NORTHSIDE HIGH SCHOOL

SPECTRUM DESIGN PROJECT NO. 06055

PROFILES -
STORM DRAIN

C-2.5

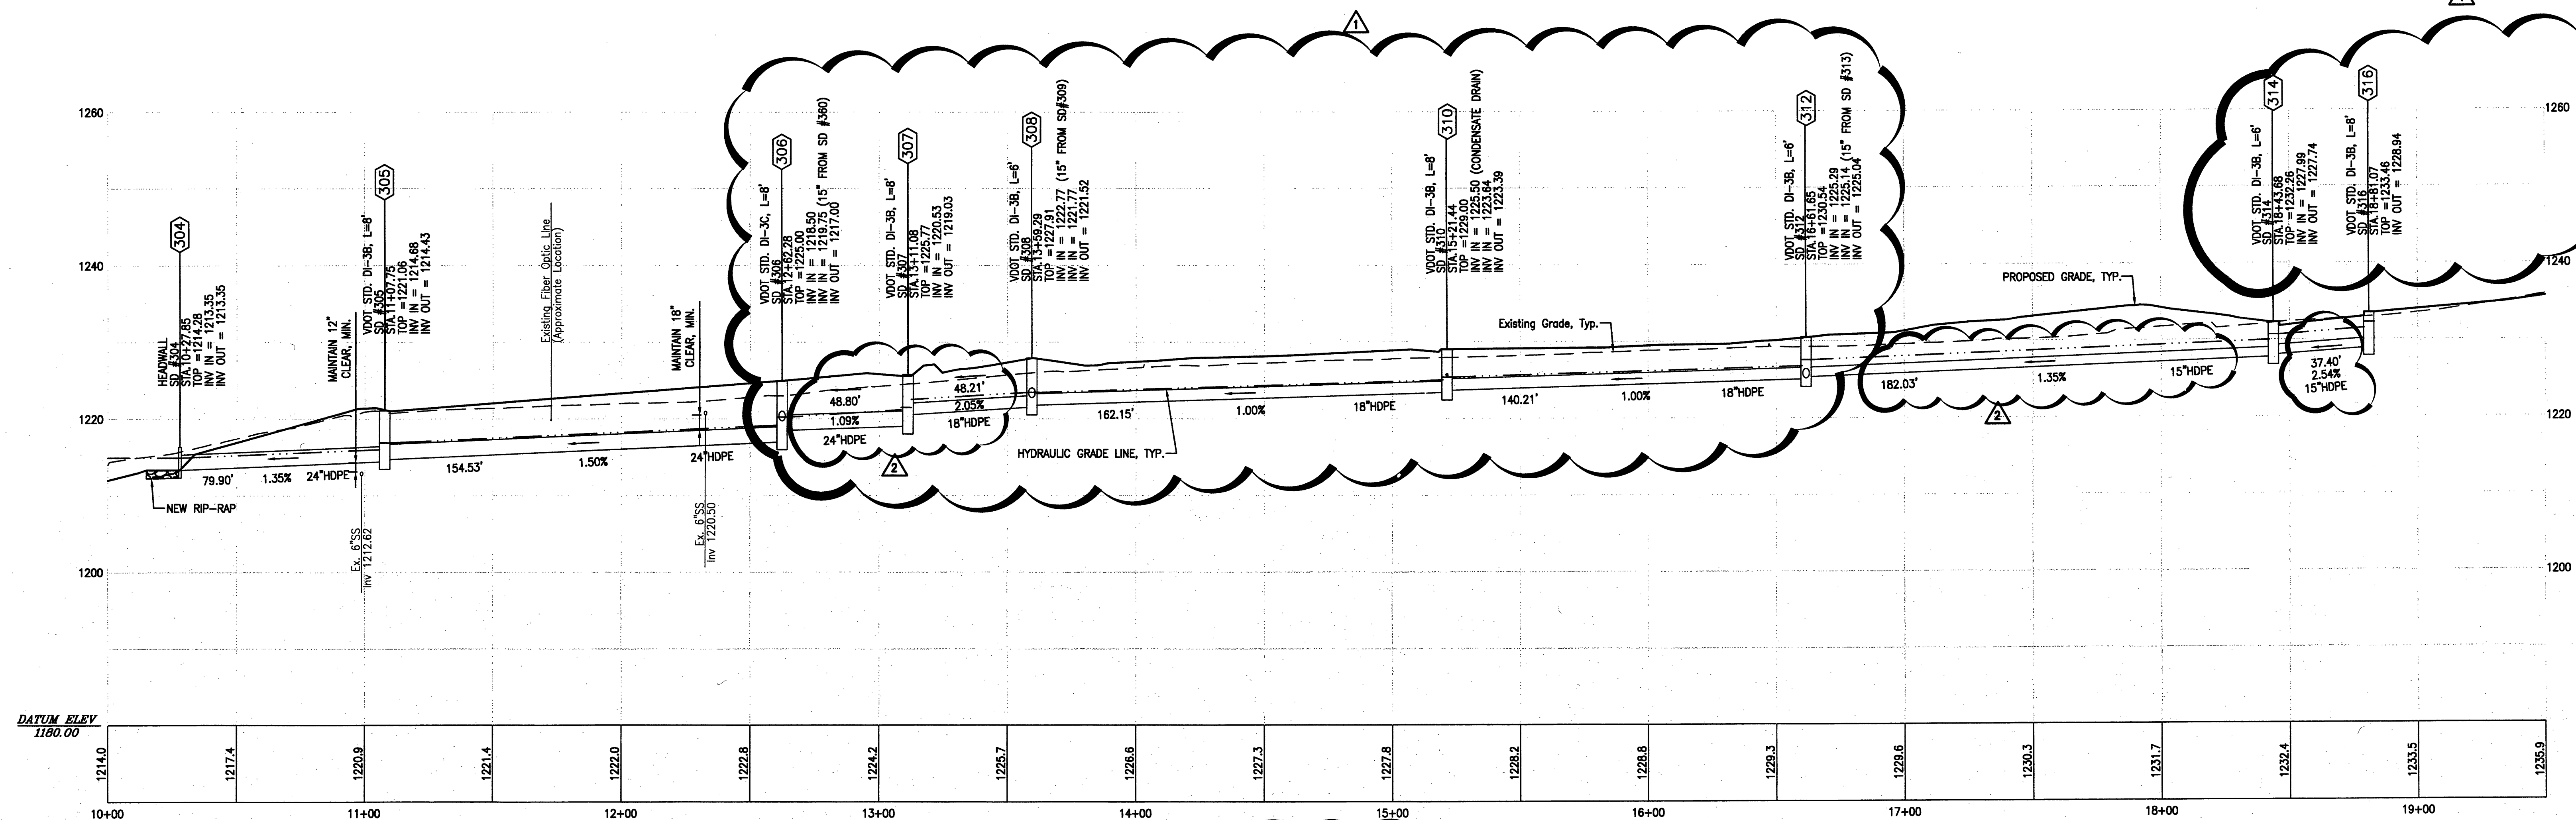
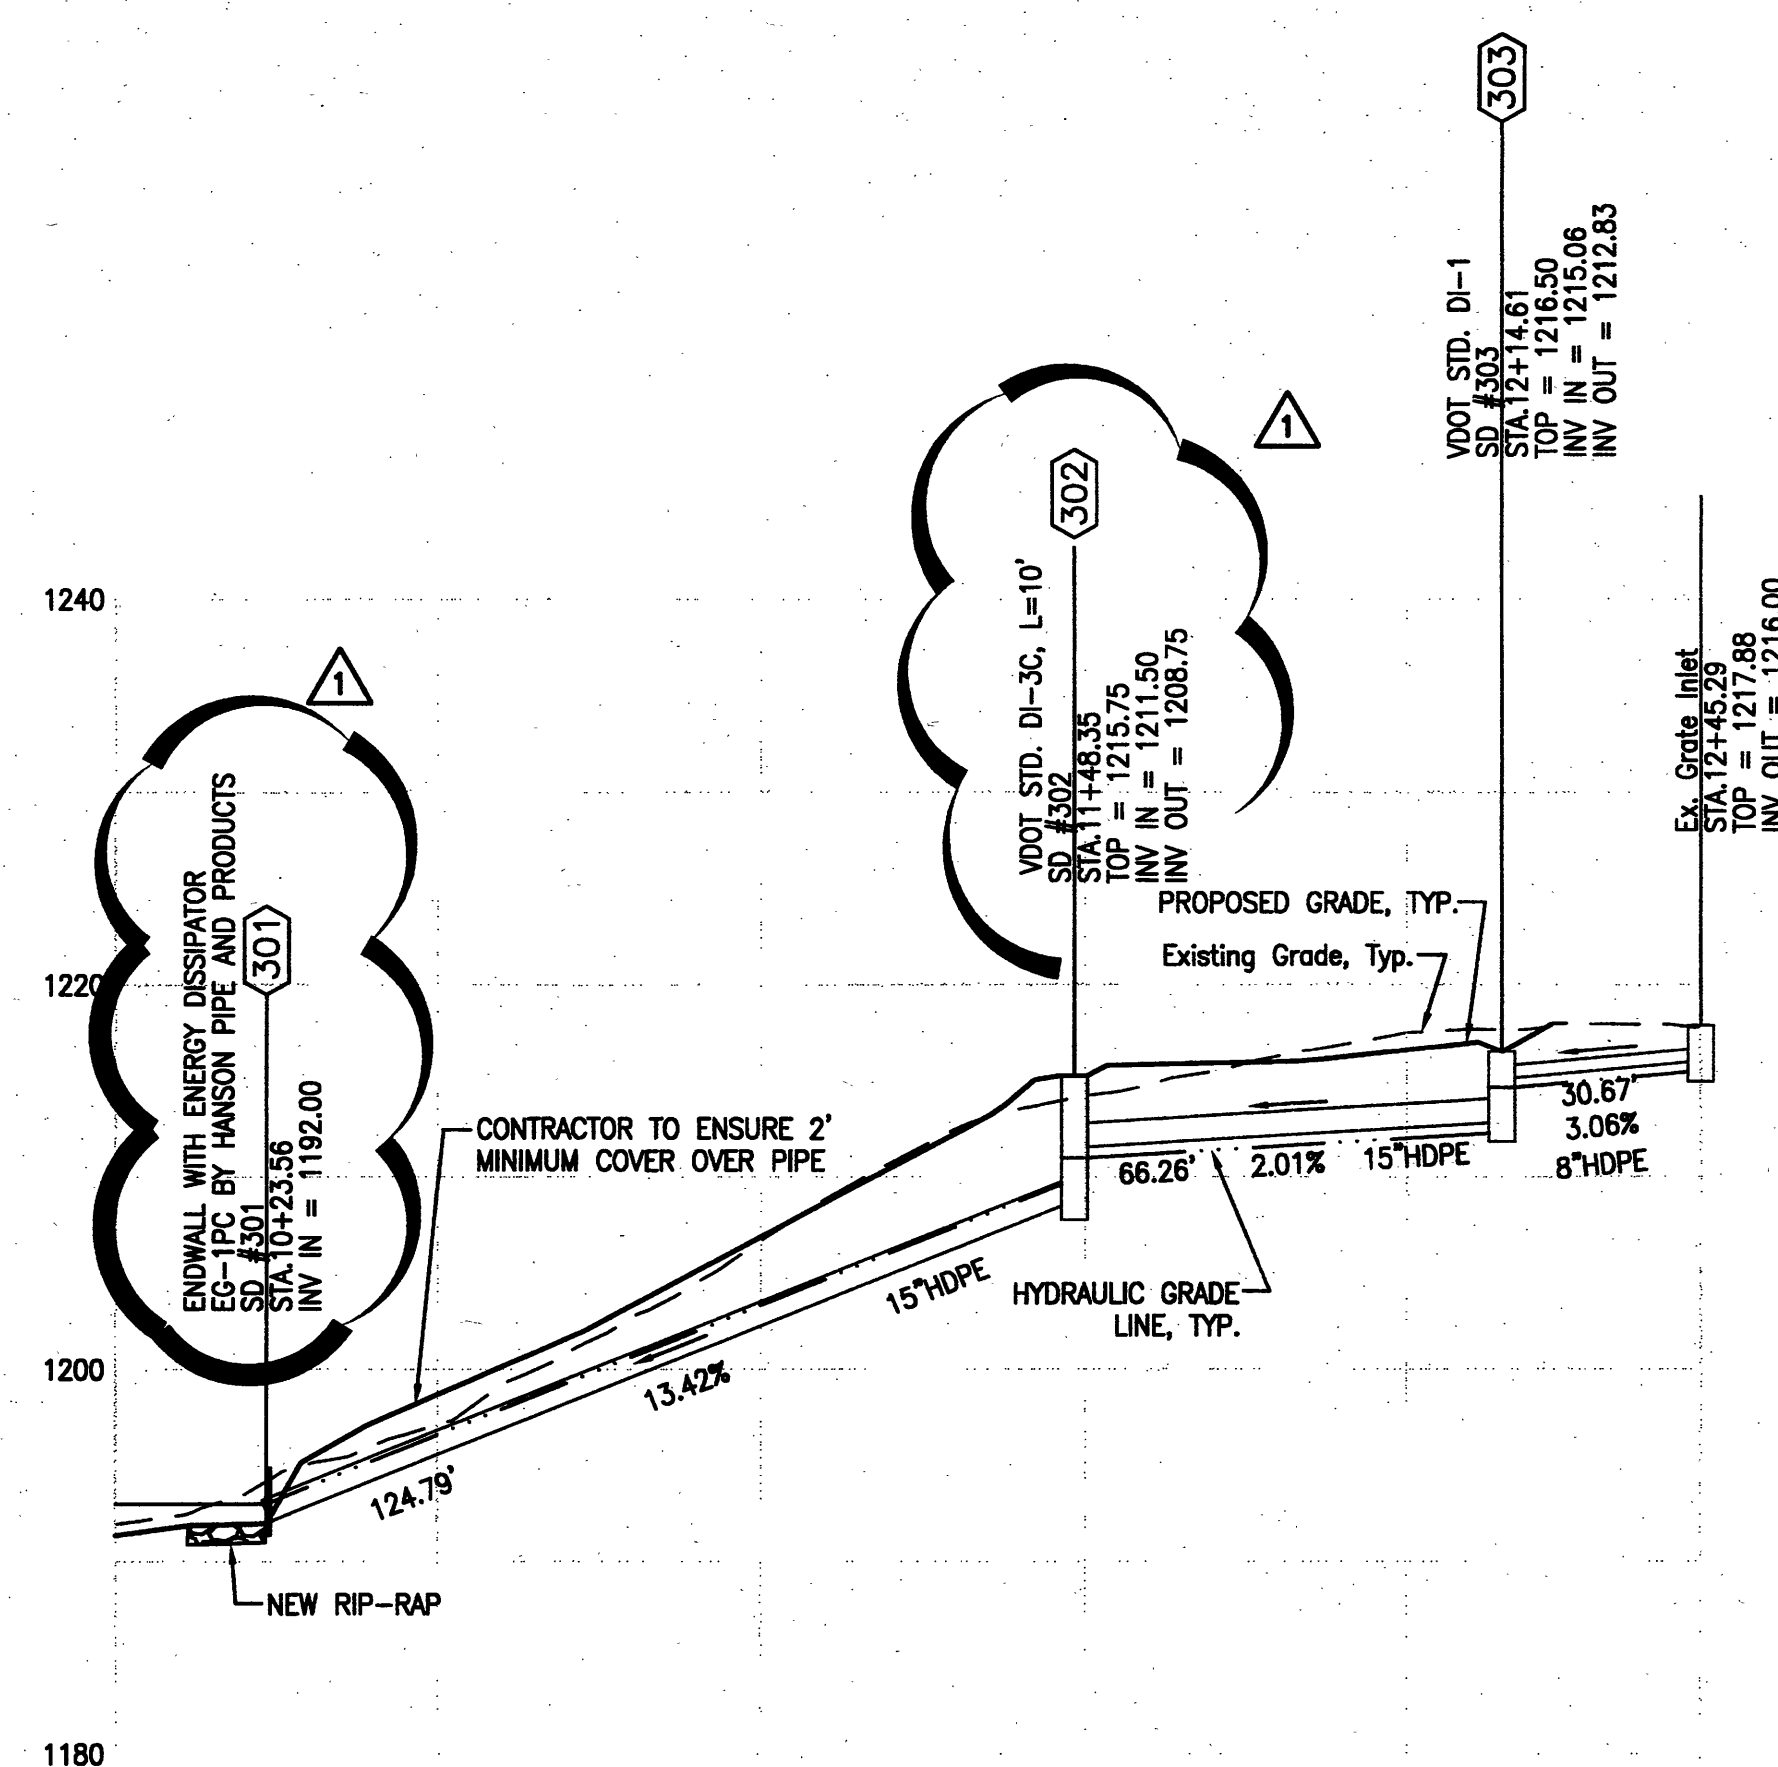
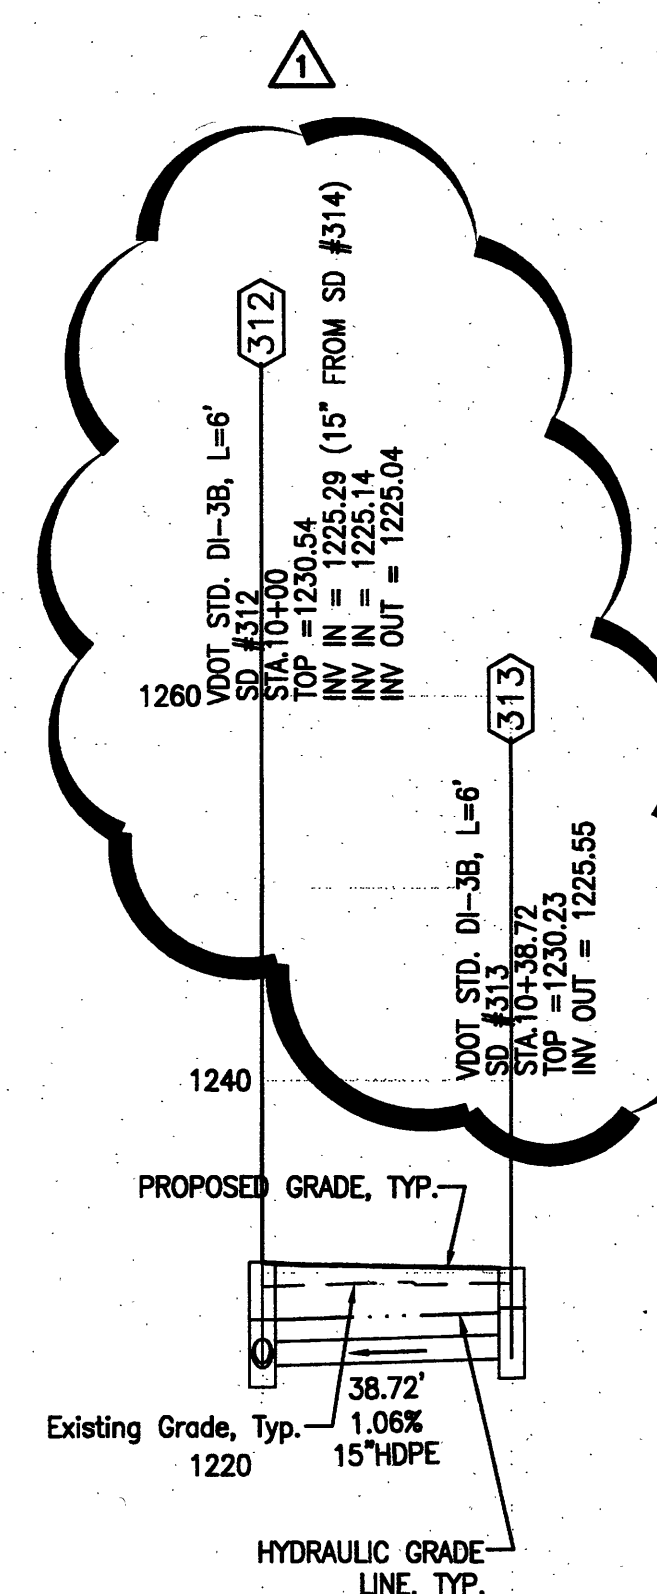
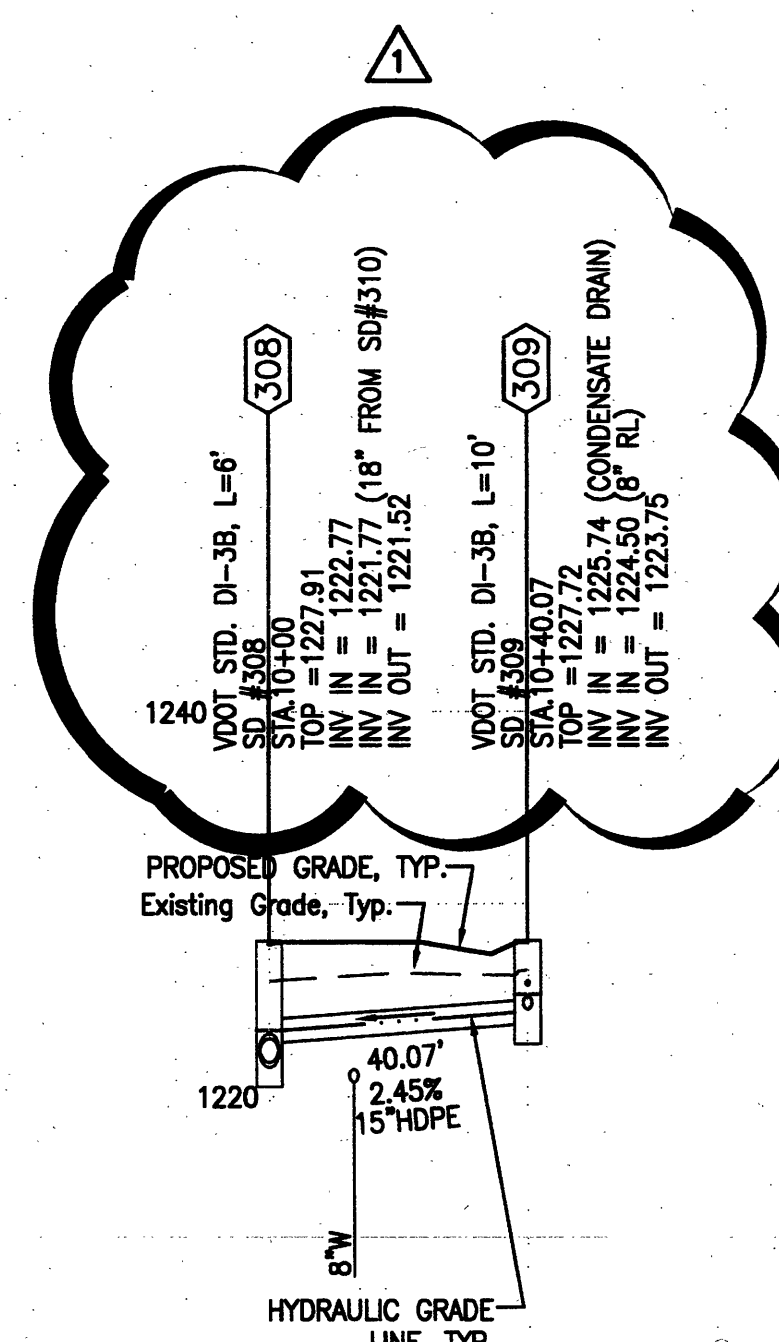
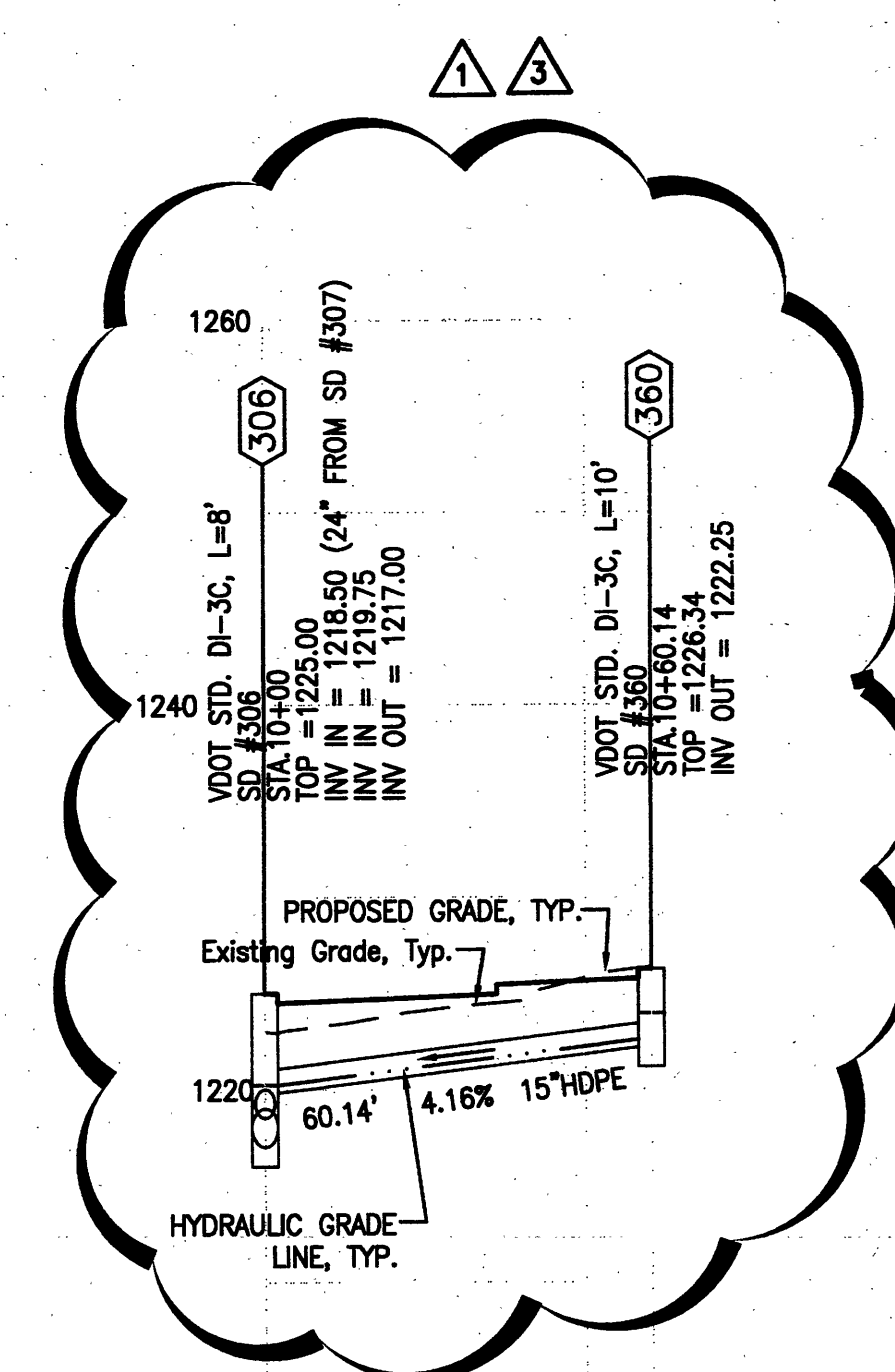
REVISION #2 CHANGES:
ALL STORM DRAIN PIPE MATERIAL HAS BEEN CHANGED TO HDPE. ADDITIONALLY, STORM DRAIN TOP ELEVATIONS HAVE BEEN REVISED DUE TO THE ELIMINATION OF THE GUTTERS (PHASE I).

2. THE ANNOTATION OF ALL STORM DRAIN STRUCTURES HAVE CHANGED FROM "RIM" TO "TOP" ELEVATIONS. IN THE CASE OF CURB INLETS, "TOP" INDICATES THE TOP OF THE STRUCTURE/TOP OF CURB ELEVATION. IN THE CASE OF DROP INLETS, THE "TOP" ELEVATION INDICATES THE TOP OF GRATE ELEVATION.

3. STORM DRAIN PIPING MATERIAL SHALL BE CORRUGATED HIGH-DENSITY POLYETHYLENE (HDPE). COVER AND INSTALLATION SHALL COMPLY WITH THE COUNTY OF ROANOKE INSPECTION SPECIFICATIONS FOR HDPE PIPE.
